CITY OF
SARATOGA SPRINGS

Planning Commission Meeting
Thursday, March 13, 2014
Meeting held at the Saratoga Springs City Offices
1307 North Commerce Drive, Suite 200, Saratoga Springs

**Concept Plan
Green Springs
March 13, 2014
Public Meeting**

Author: Jeremy D. Lapin, City Engineer
Subject: Green Springs – Concept Plan
Date: March 13, 2014
Type of Item: Concept Plan Review

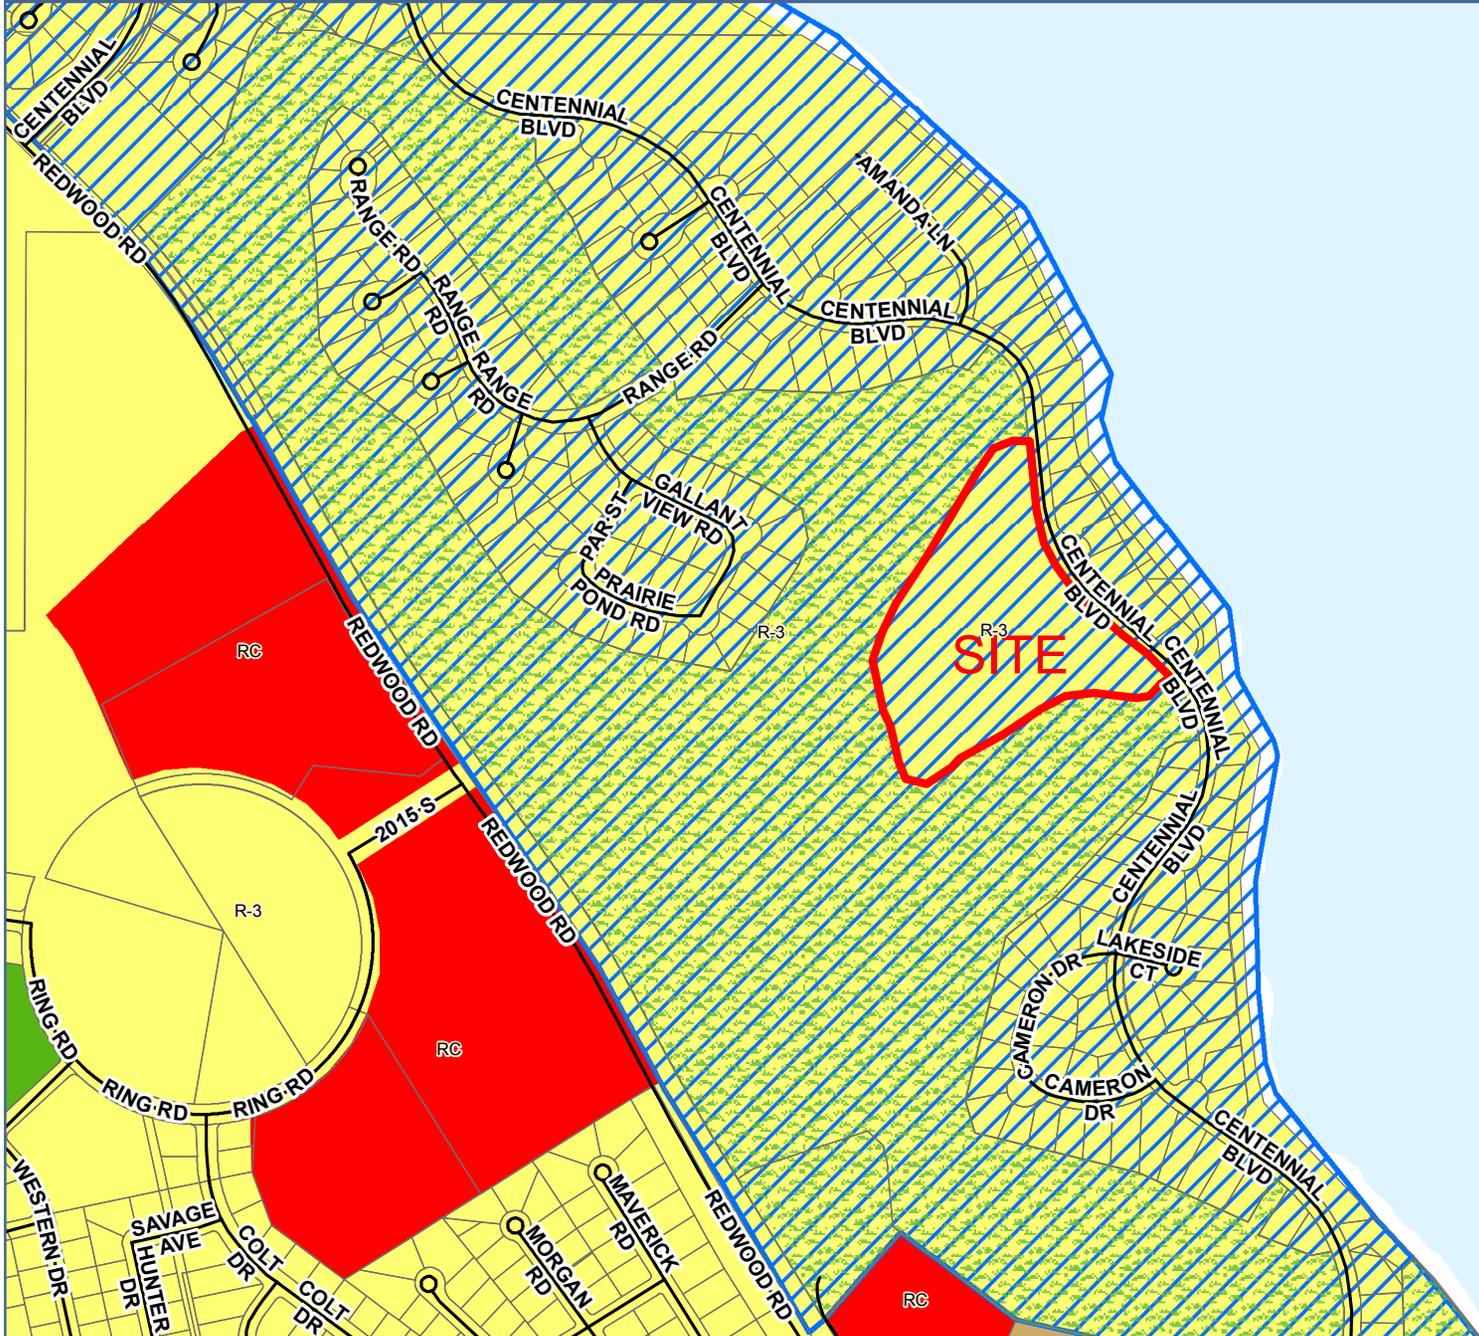
- A. Prepare construction drawings as outlined in the City's standards and specifications and receive approval from the City Engineer on those drawings prior to receiving Final approval from the City Council.
- B. Consider and accommodate existing utilities, drainage systems, detention systems, and water storage systems into the project design. Access to existing facilities shall be maintained throughout the project.
- C. Comply with the Land Development Codes regarding the disturbance of 30%+ slopes.
- D. Incorporate a grading and drainage design that protects homes from upland flows.
- E. Project must meet the City Ordinance for Storm Water release (0.2 cfs/acre for all developed property) and all UPDES and NPDES project construction requirements.

- L. Provide an overall drainage schematic and ensure that any proposed drainage basins do not impact the existing drainage channel including impacts that may affect the capacity and/or slope stability of the channel. Provide easements for any infrastructure located outside the plat boundary.

- M. Proposed plat cannot create any remnant parcels.
- N. Developer shall provide a hard surface access to all sewer manholes that are outside of the public ROW.

- O. Consider protection from errant golf balls on all lots adjacent to the golf course, especially lots 7 through 12.
- P. Relocation of the existing sewer may not reduce capacity (pipe slope) and will need to have complete plans for the construction of the sewer main, the complete removal of the existing main to be abandoned, and plans for bypass pumping of sewage during construction.

Author: Jeremy D. Lapin, City Engineer
Subject: Platinum Car Wash – Concept Plan
Date: March 13, 2014
Type of Item: Concept Plan Review

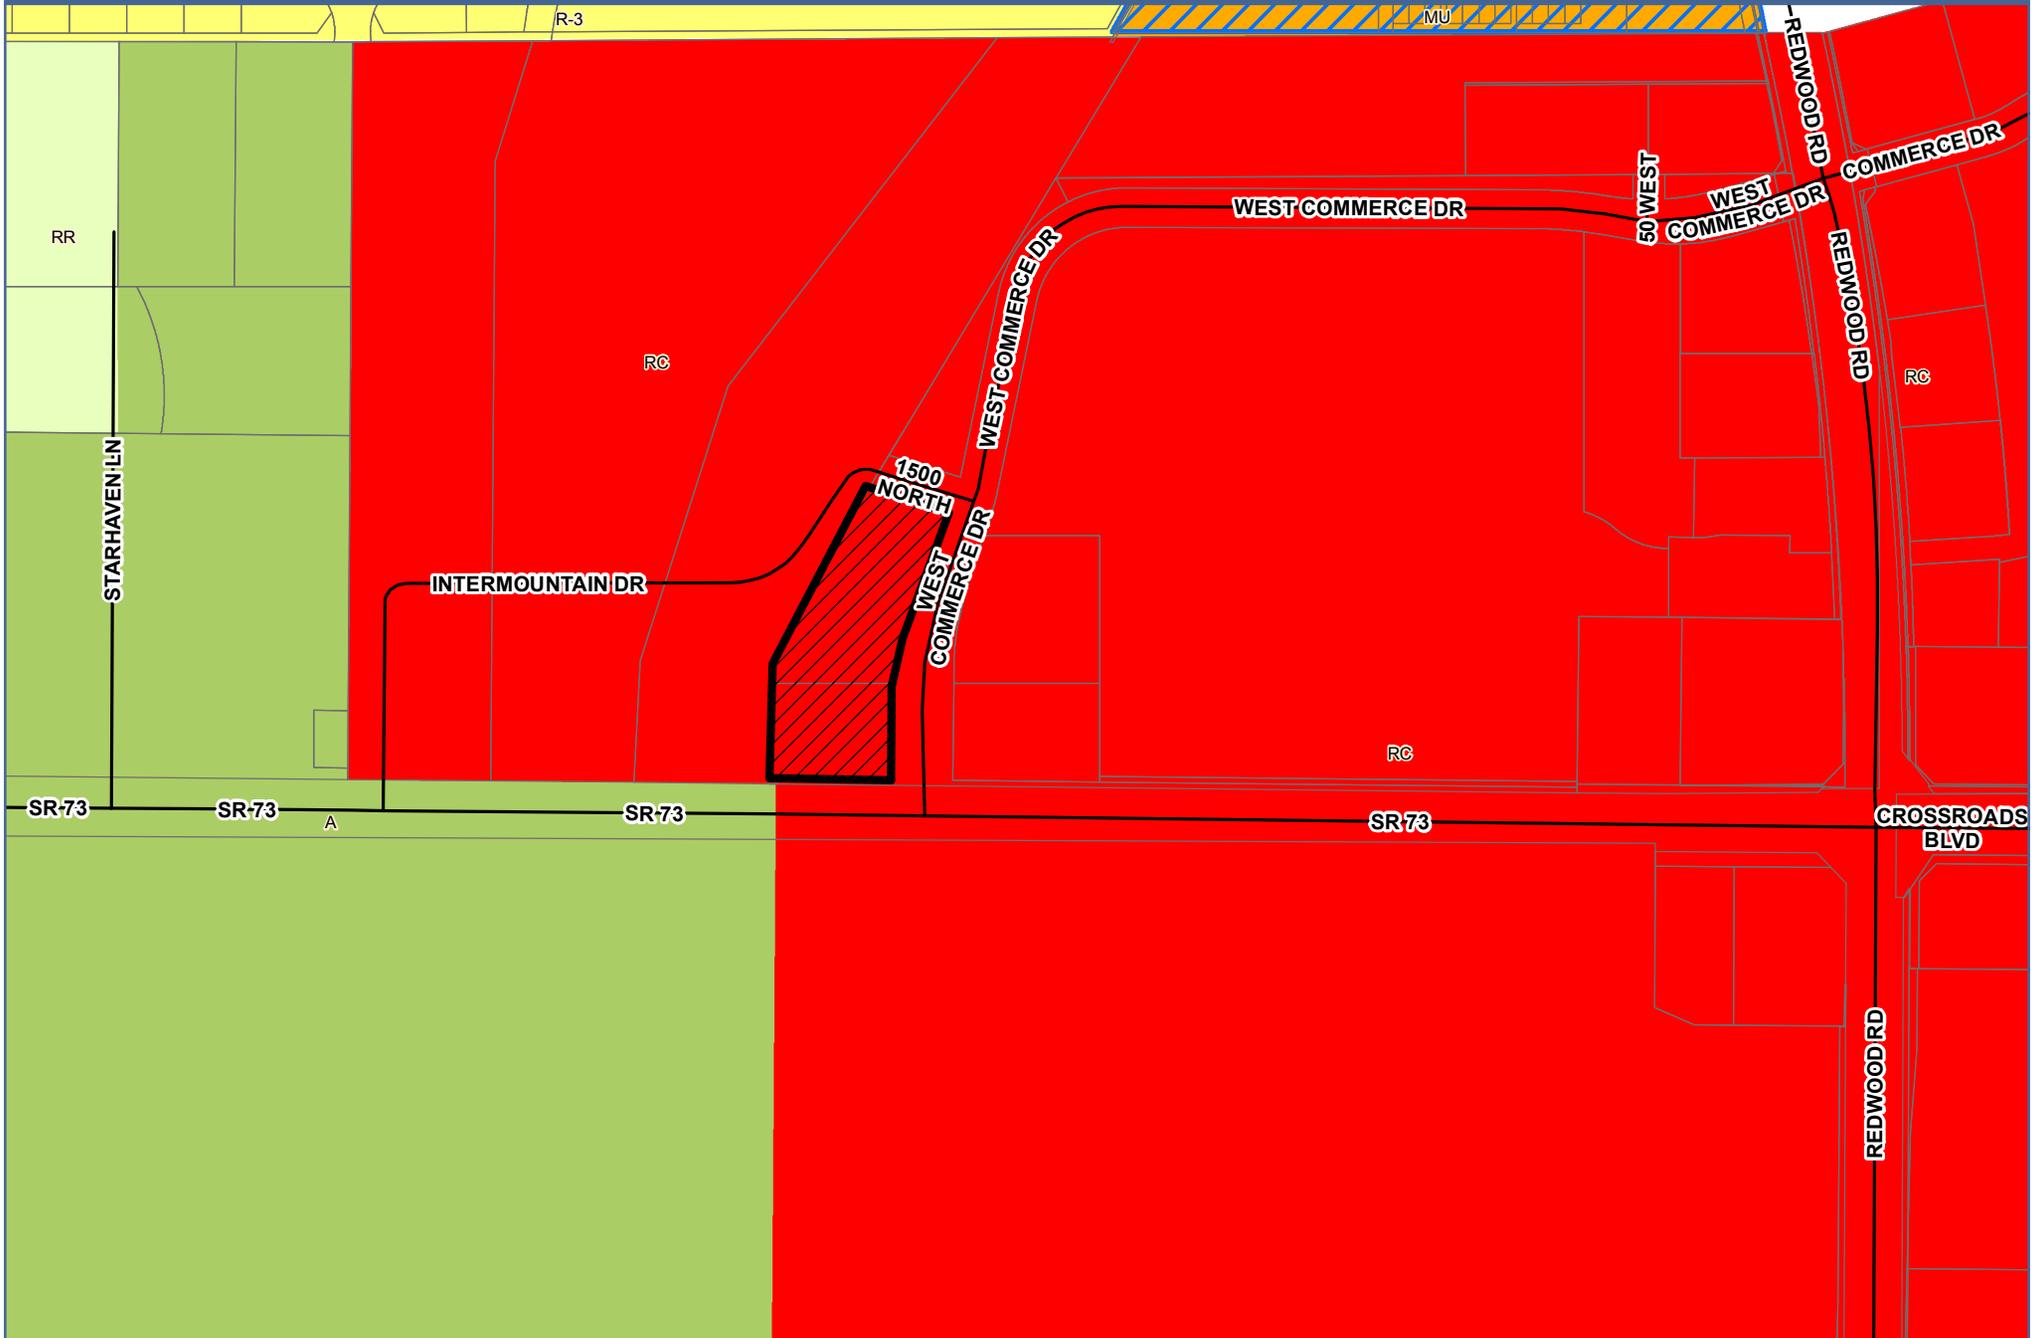
- A. Based on the proposed concept plan a lot line adjustment will be required prior to site plan approval. The remaining lot shall meet the minimum lot requirements for the regional commercial zone.

- C. Comply with the Land Development Codes regarding the disturbance of 30%+ slopes.
- D. Project must meet the City Ordinance for Storm Water release (0.2 cfs/acre for all developed property) and all UPDES and NPDES project construction requirements. Storm water must be treated to remove 80% of TSS and all hydrocarbons and floatables prior to discharge into the City system.

- J. Provide a comprehensive geotechnical report.
- K. Provide comprehensive drainage calculations.
- L. Parking stalls shall have an island every 10th stall, to comply with the City Land Development Code.

- N. Provide adequate and safe pedestrian access from Commerce Drive to the Site and building. Routing pedestrians down a drive isle does not seem safe or acceptable.

- Q. A cross access easement shall be provided for the adjacent lot to the north
- R. Provide an erosion control plan with BMP's and BMP details. Contractor must obtain an NOI from the state prior to commencing construction.

- S. Provide complete landscaping and irrigation plans.
- T. Provide details for all site items and structures, city standard or other.

SHEET TITLE
LANDSCAPE PLAN

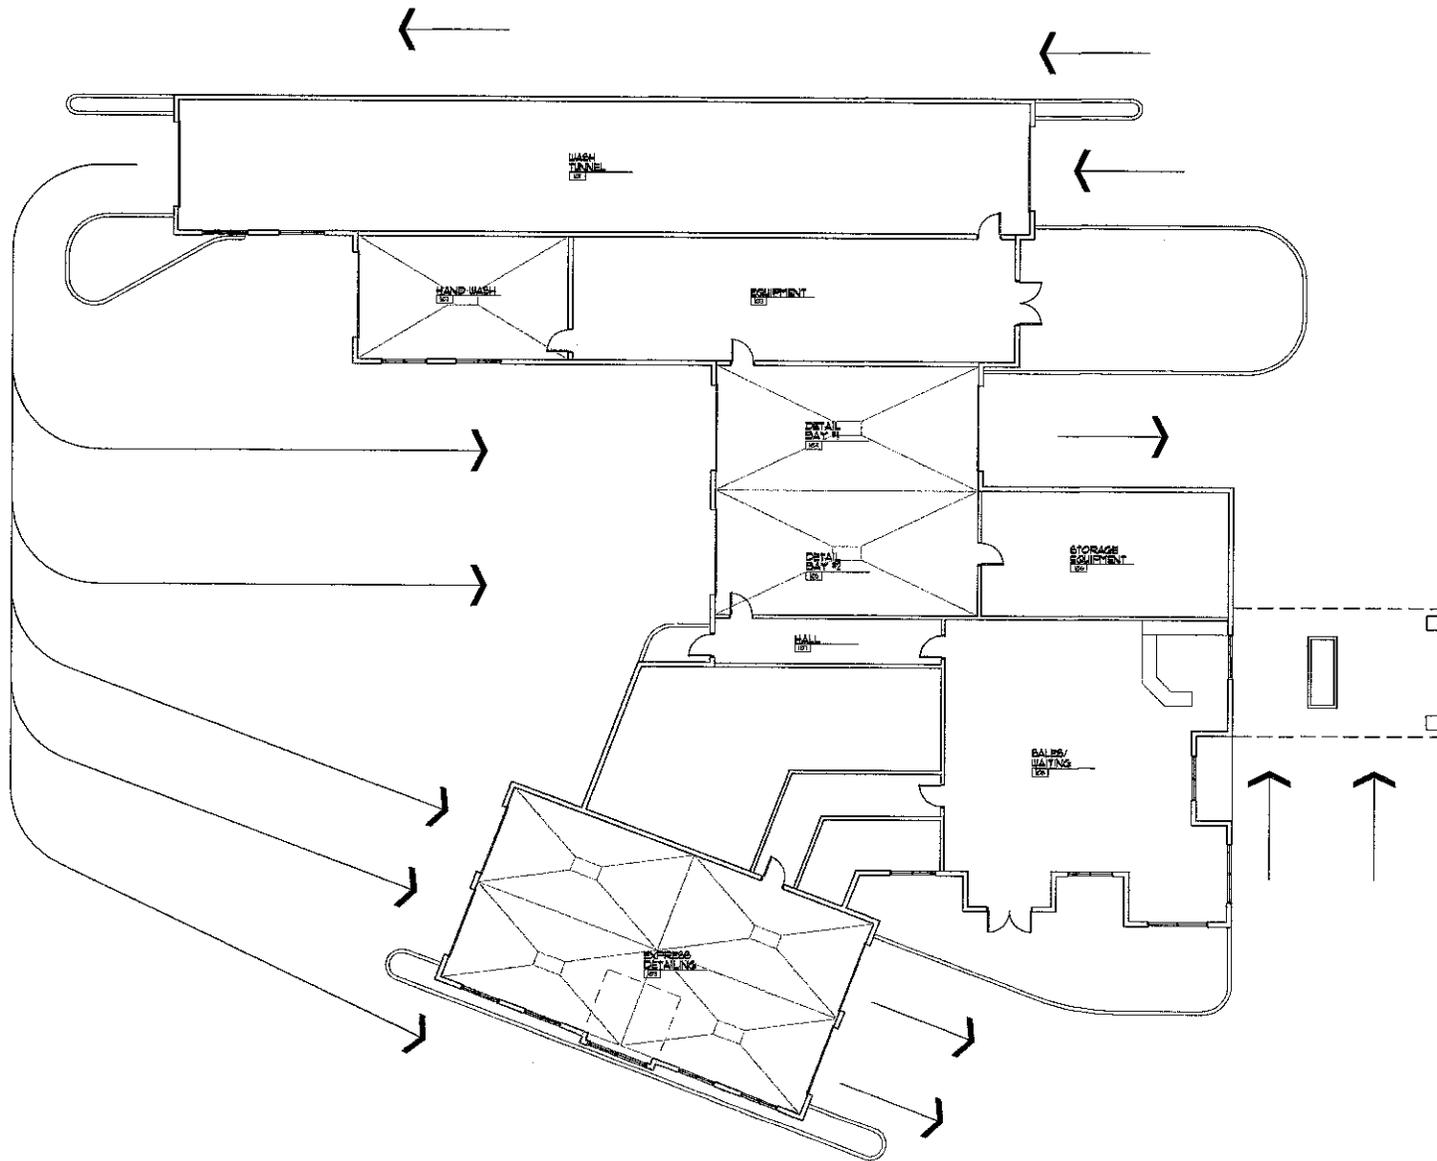
Development Standards: does not comply. The development standards include requirements for architectural review and landscape plan review which will be reviewed further with the site plan application because landscape plans and elevations are not required with the concept plan submittal. *However, the landscape area within the required front setback is 6.86 feet (rather than the 20 feet) at its narrowest and does not comply with Section 19.04.22(9)(b)(i).*

Section 19.04.22(9)(b)(i) states "required front yard areas, and other yard areas facing a public street, shall have a landscaped area of not less than twenty feet (or as reduced in subsection 5.b. above) as approved through the Site Plan review process." Subsection 5.b. contains no criteria for reducing the 20 ft. landscaping requirement. However, the old criteria (prior to July 2013) in 5.b. stated that the Council may reduce setbacks (front and rear) to ten feet if "the reduction provides a more attractive and efficient use of the property." Therefore, staff has determined that this is the proper standard to use for reducing the front landscaping requirement. Following are possible reasons to grant or deny the reduction:

Landscaping Requirements: complies. Twenty percent of the total project area is required to be landscaped and all sensitive lands shall be protected. *The plans indicate 35% of the site will be landscaped and there are not any sensitive lands within the project area.*

LAKE COVE SUBDIVISION CONCEPT PLAN

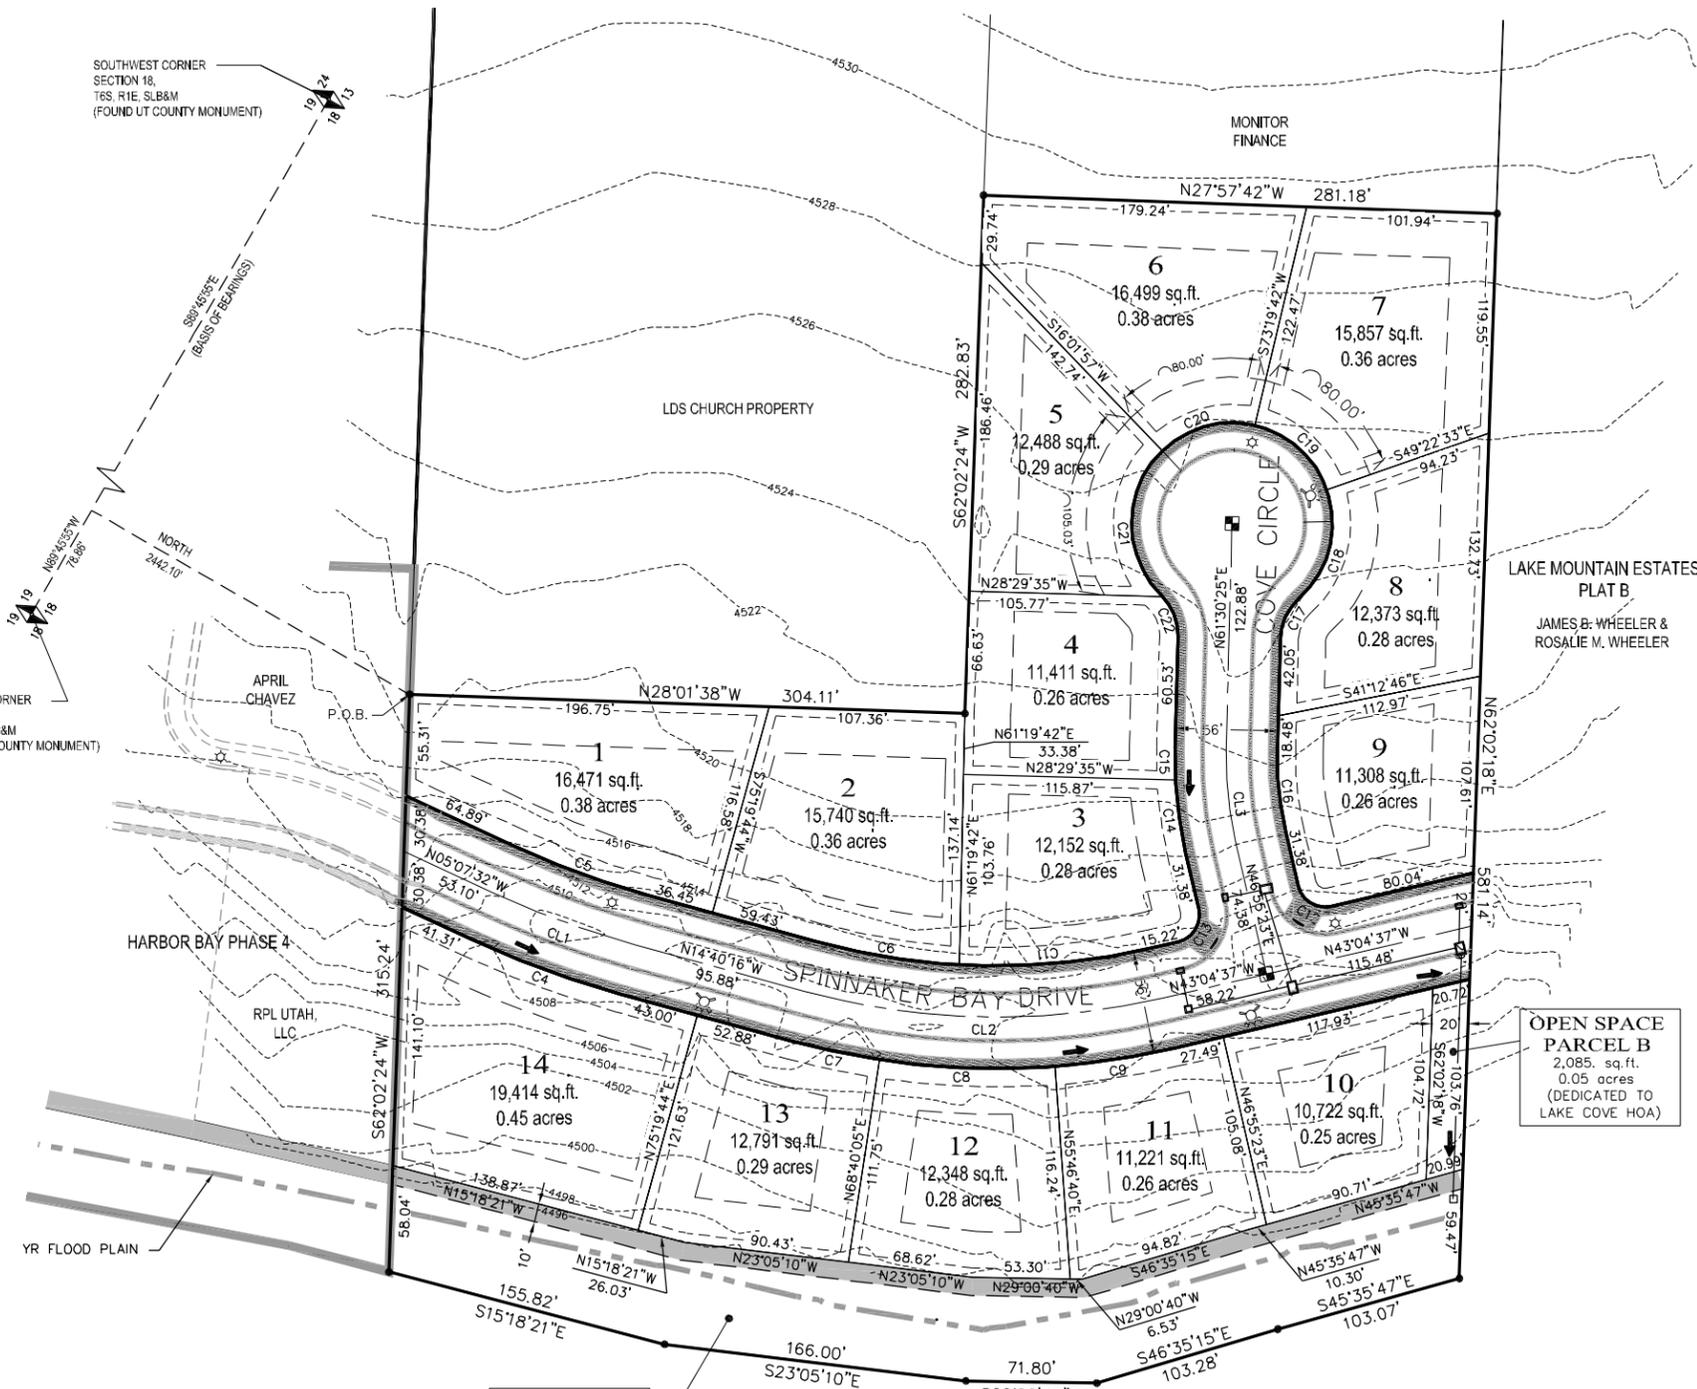
Access to the proposed lots comes from Spinnaker Bay Drive, which is currently a 2,786 foot long dead-end street. The City Code is currently be amended to address second access requirements. These changes have received a favorable recommendation from the Planning Commission and will be presented to the City Council on March 25, 2014 for possible adoption. Since these amendments will likely be adopted by the City Council, and this subdivision will be required to meet these standards, we recommend that the applicant be informed of these pending code amendments, which are:

Based on this pending ordinance change, the Lake Cove subdivision will have to provide another road access from McGregor Lane to Spinnaker Bay Drive via either the extension of Harbor Bay Drive or Catamaran Way.

Open Space: can comply. The City Code requires a minimum 15% open space. The Concept Plan indicates that there is approximately 0.83 acres of open space; however, approximately 0.5 acres of this open space is within the 100 year flood plain and therefore designated as sensitive land.

If 50% of the area designated as sensitive land is counted toward meeting the open space requirement, then the proposed Concept Plan provides approximately 9% open space. The applicant has the option of requesting a payment in lieu of open space to make up the difference. The applicant has indicated that they plan on pursuing this option when they submit their Preliminary Plat application.
